Subject: CZ-19-0673-42 – Design Build Construction of Heating, Ventilation, and Air Conditioning (HVAC) at Multiple Sites – Package A (SDUSD Project # 92550071.1)

Notice to Proceed: No. 17– Paint Rooftop Duct at Sessions Elementary School

Project: SDUSD HVAC Design Build Projects **Contingency Adjustment Proposal No:** Sessions ES 06r2

Contract No: CZ-19-0673-42 **Subject:** Paint Rooftop Duct, stands and RTU trim per SDUSD provided plan and direction.

BLDG# 01-01, 01-05, & 03-07 MECHANICAL ROOF PLAN

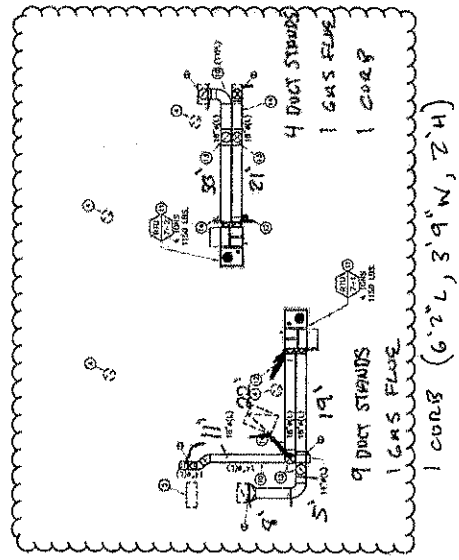
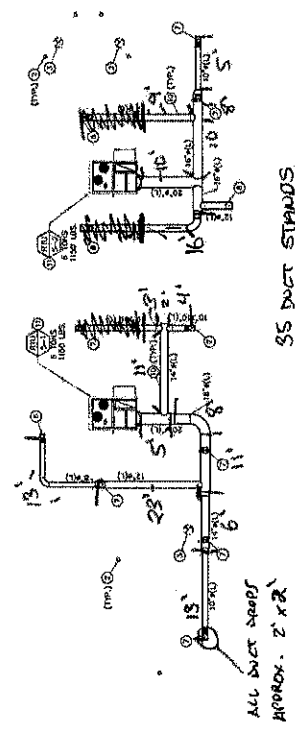
Last Friday Dale, Ramon, and myself reviewed the scope of ductwork that the Criteria Architect team has proposed to be painted. I've attached drawings indicating the duct to be painted and the measurements we took for reference. Also, here is the link to Marcatects' survey: <https://marcatects.sharefile.com/d-sff267c853b049958> which can also be found on AERO. I would kindly ask that Soltek provide the District with a cost proposal to paint the rooftop ductwork proposed by the Criteria Architect team.

The Criteria Architect teams' proposal includes the painting of all rooftop ductwork and duct stands at Bldgs. 02 and 07. Also at Bldg. 07, the RTU curbs and gas flues are to be included in the scope. Most of the ductwork and duct stands are to be included in the scope at Bldg. 05 with the exception of (3) duct runs on the North ridge of the roof.

Includes all material and labor costs to provide and install the upgrade high-performance coating at rooftop exterior duct, duct stands and RTU trim per attached plans prepared by SDUSD. Includes all prep, protection and clean up. Includes 2 coats finish over 1 coat primer.

- A. Primer: Macropoxy 646-100 Fast Cure Epoxy -B58T00624
- B. Intermediate: Sher-Loxane 800 High-Performance Polysiloxane - B80W501 - Special Order Satin Sheen
- C. Top Coat: Sher-Loxane 800 High-Performance Polysiloxane - B80W501 - Special Order Satin Sheen

OVERALL ROOF PLAN - ENLARGED FOR SCREENS 1" = 20'-0"

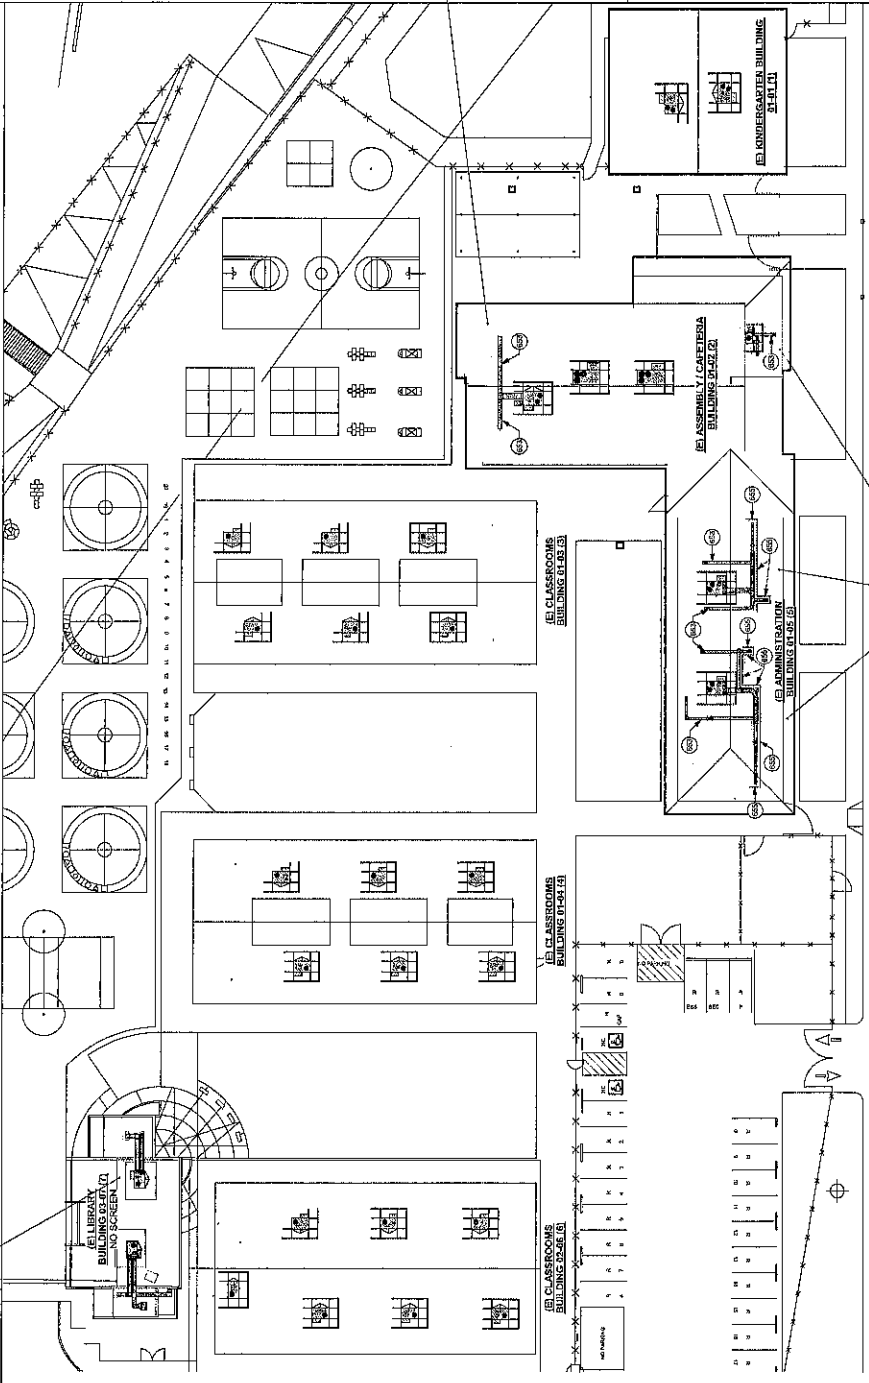
653 PAINT NEW ROOF MOUNTED DUCTS AND DUCT STANDS
 656 ADD SCREEN MATERIAL ATTACHED TO THE SIDE OF DUCT STAND POSTS

Per Chien Architect site visit: 5/13/20:
 It was observed that s on certain areas of the rooftop ductwork, a paint or masking is recommended due to the following factors:
 1. Roofing ductwork creates an intense glare that affects pedestrians and neighbors on Beryl Street. (See pictures on page 4-6)
 2. Roofing ductwork creates an intense glare that affects motorists driving west to east on Beryl Street and vice versa. This is especially true during the winter months when the sun is lower in the sky. It is recommended that some paint or masking be applied to the ductwork in question. See pictures and marked.
 3. Roofing ductwork creates an intense glare that affects neighbors behind the school. North and North West (Inside homes) (See pictures on page 2 and 3)
 These recommendations are to be discussed and approved per Project Coordinator and CMVA. Cost will have to be provided per GC.
